MIL-T-81077A(OS)
Amendment 2
29 April 1969
Superseding
Amendment 1
20 January 1967

TEST SET, ELECTRICAL CABLE

MARK 444 MOD 0

(For Torpedo Mk 46 Mods 0 and 1)

FIGURE 2. INSULATION TEST FIXTURE

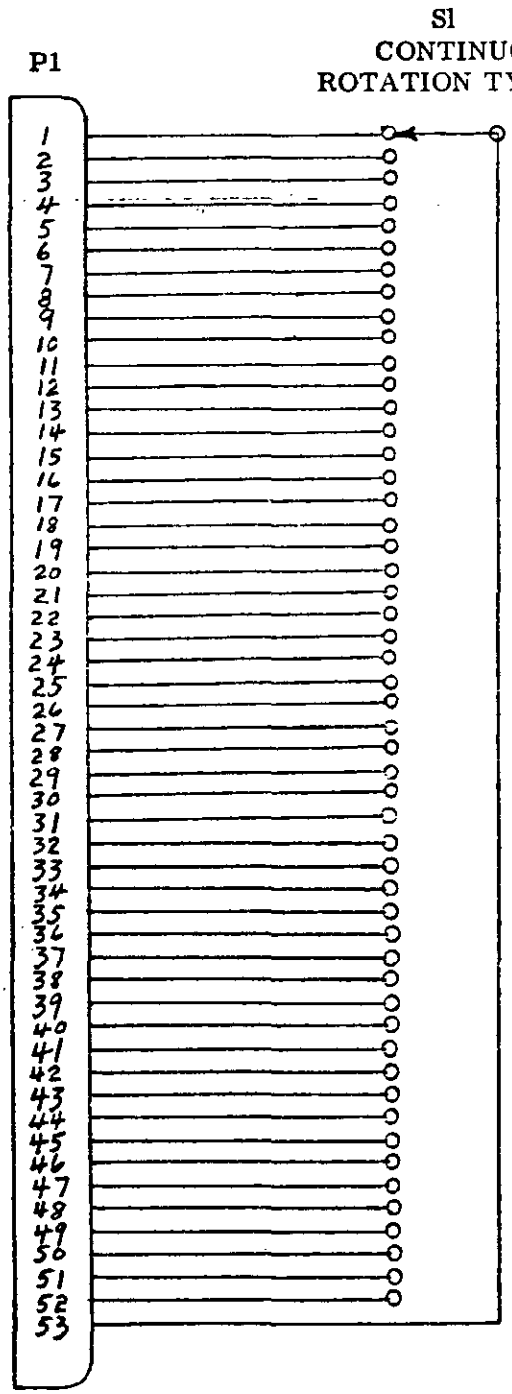
Page 8, paragraph 4.5.1. Add after subparagraph (f):
"(g) Insulation test fixture in accordance with Figure 2".

Page 13, paragraph 4.7.3.1. Add after subparagraph (r):
"(s) Disconnect the checkout cable from connectors J1 and J3.

(t) Connect the insulation test fixture to connector J1 as illustrated in Figure 2.

Page 13: Add Figure 2 after paragraph 4.7.3.1.
